DOCKET ITEM #2
Special Use Permit #2011-0068
1001 Jefferson Street – Athletic Field Lighting

Application	General Data	
Consideration of a request to add lighting to an existing athletic field.	**Planning Commission Hearing:**	June 5, 2012
	City Council Hearing:	June 16, 2012
Address: 1001 Jefferson Street	**Zone:**	POS/Public Open Space and Community Recreation
Applicant: City of Alexandria, Department of Recreation, Parks, and Cultural Activities	**Small Area Plan:**	Southwest Quadrant

IV. CITY DEPARTMENT COMMENTS

File #: 153826R2.1 Date: 14-Sep-11

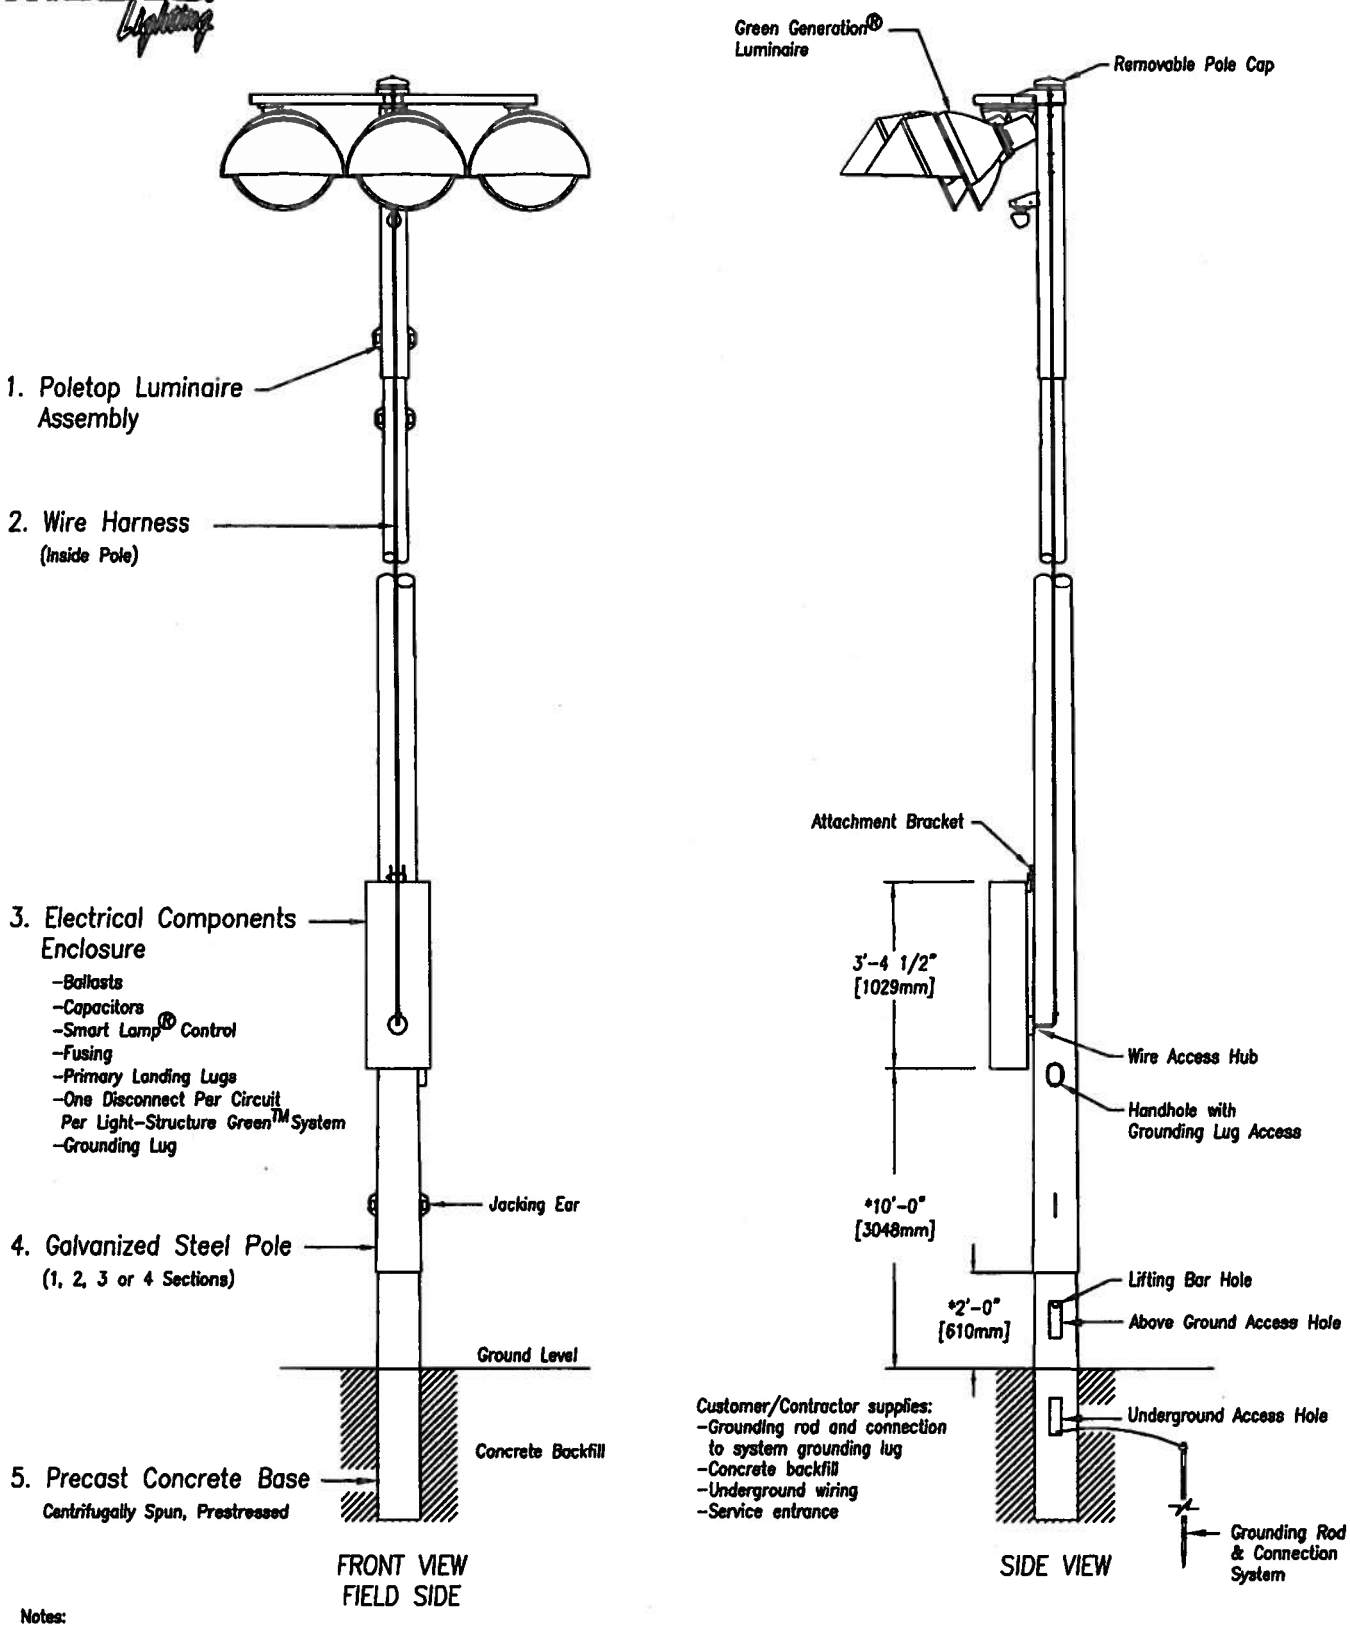
F-1 The Illumination Summaries, File #153826R2 and #153826R2.1 dated 14-Sep-11 show the minimum lighting levels as 0; however, still provide ratios of Avg/Min and Max/Min while mathematically these ratios must be infinity. (T&ES)

c. Manufacturer's specifications and details for all proposed fixtures including site, landscape, pedestrian, sign(s) and security lighting.
d. A photometric plan with lighting calculations that include all existing and proposed light fixtures, including any existing street lights located on the opposite side(s) of all adjacent streets. The Illumination Summaries, File #153826R2 and #153826R2.1 dated 14-Sep-11 provided with the Preliminary submission show the minimum lighting levels as 0; however, still provide ratios of Avg/Min and Max/Min while mathematically these ratios must be infinity. Therefore, remove the grid lines showing lighting levels as zero from the photometric plan such that the Avg/Min and Max/Min ratios can mathematically be defined other than infinity.
